CITY OF ALBUQUERQUE

February 21, 2019

RE: Warehouse
7601 Los Volcanes RD NW
Grading and Drainage Plan & Drainage Report
Engineer's Stamp Date: 02/05/19
Hydrology File: J10D002G

Based upon the information provided in your submittal received 02/05/2019, the Grading & Drainage Plan and Drainage Report **is not** approved for Building Permit, Grading Permit, and for action by the DRB on Site Plan for Building Permit. The following comments need to be addressed for approval of the above referenced project:

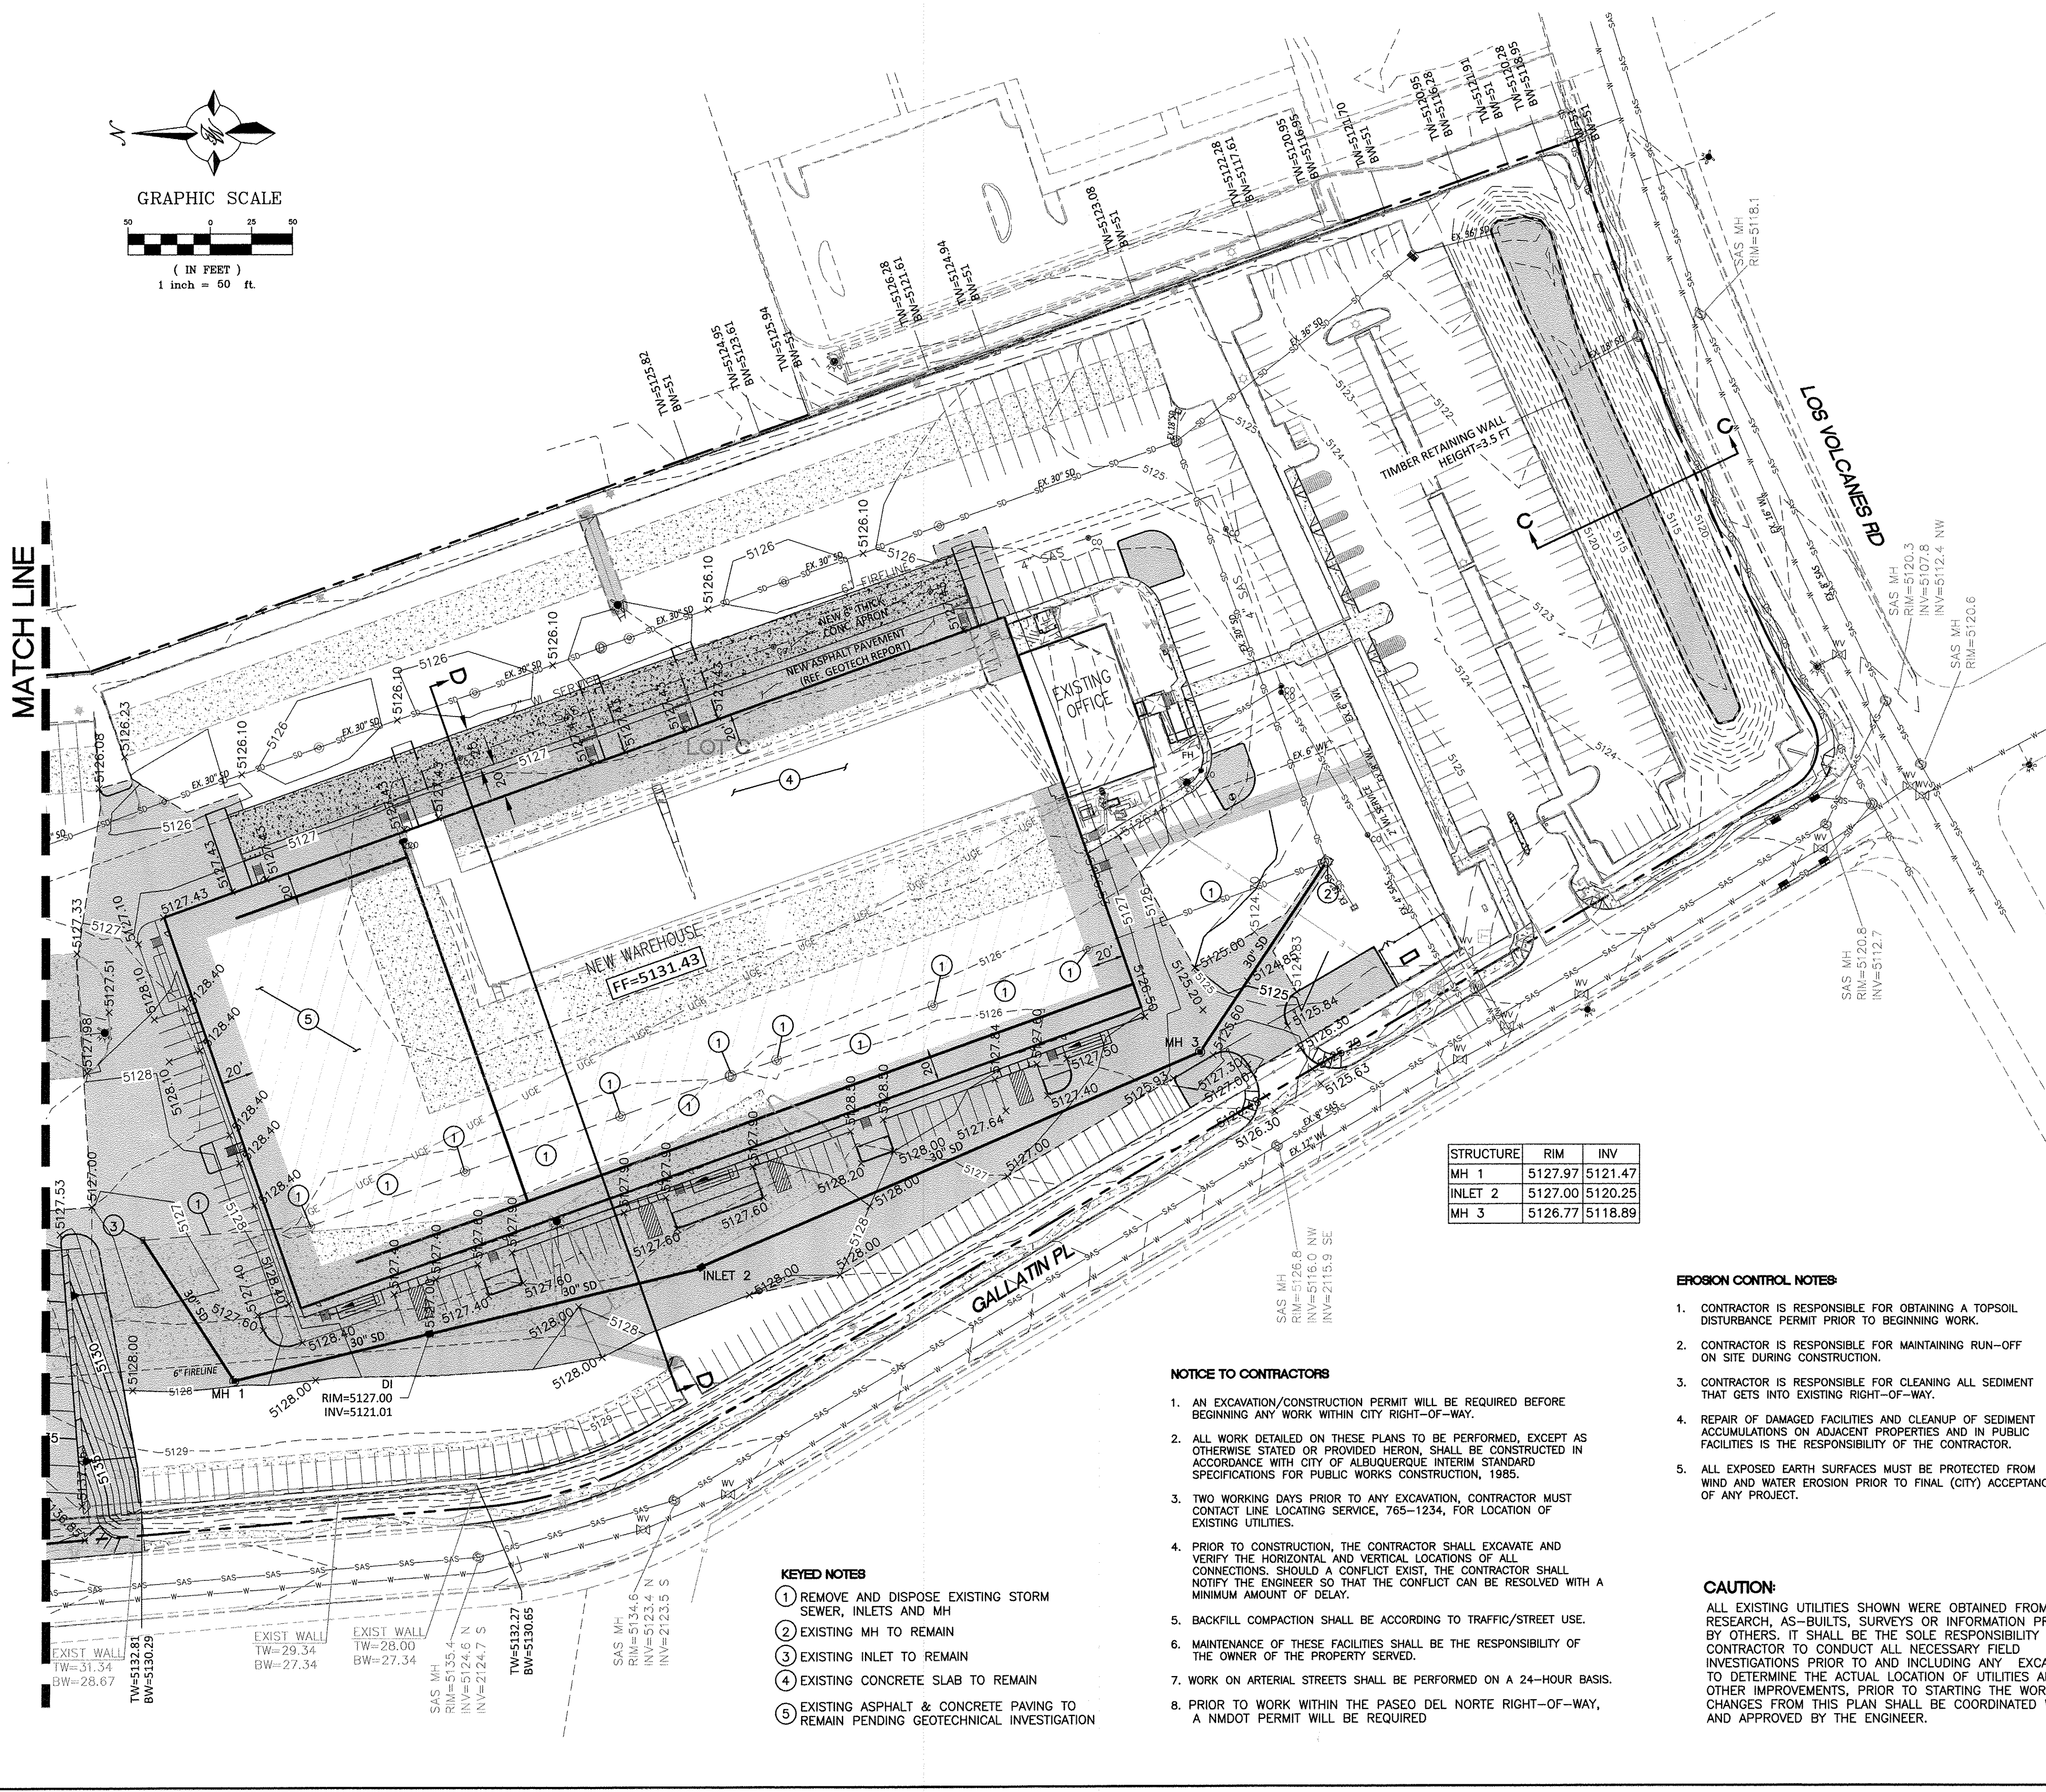
1. Sheet GR-1 & GR-2. Please clean up the Grading Plan. Whatever is going to be demolished, then please remove. Anything that is existing make lighter and anything that to be proposed, please make darker. I cannot make out what is proposed and what is staying. There are contours lines under the existing building. This doesn't happen. Also the existing building is the same line type as the proposed warehouse. Again please make the sheet better understandable of what is being proposed.

2. Sheet GR-1 & GR-2. Also if you are matching existing grades, then state this where you are doing so.
3. Please adjust the match line for Sheet GR-1 & GR-2. They currently do not line up.

SECTION C-C
NTS

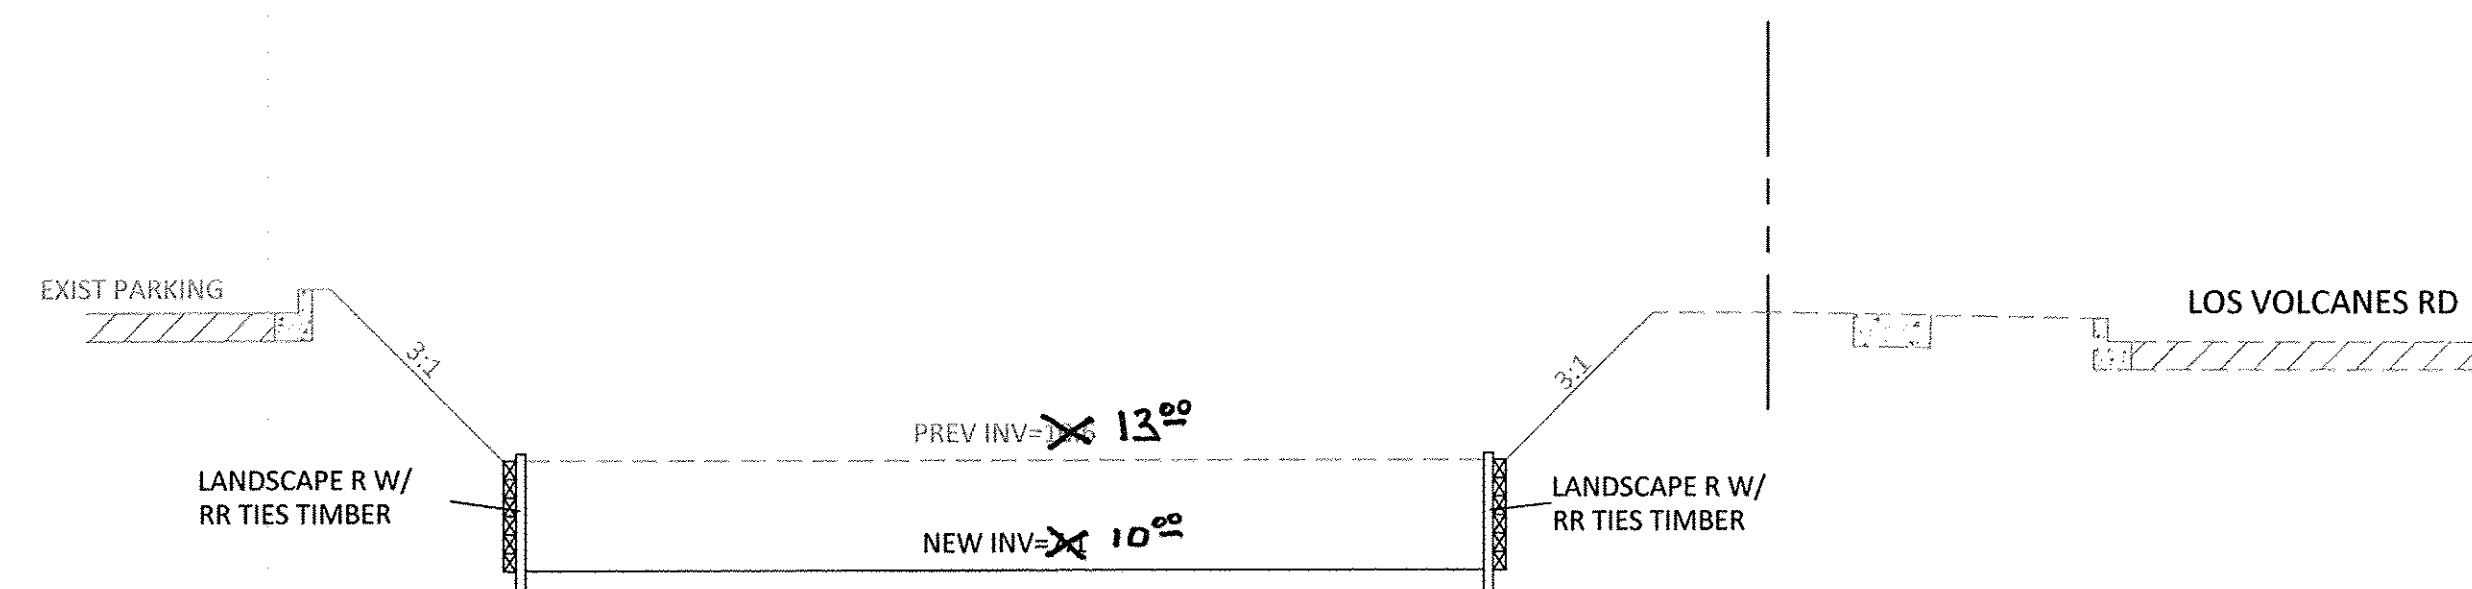
4. On Sheet GR-3, please add the WSE for the SWQ volume and the WSE for the 100 yr 6 Hr storm in Section C-C.
5. Drainage Report. Is the existing outfall structure functional? If so and will remain, please state so in the report.
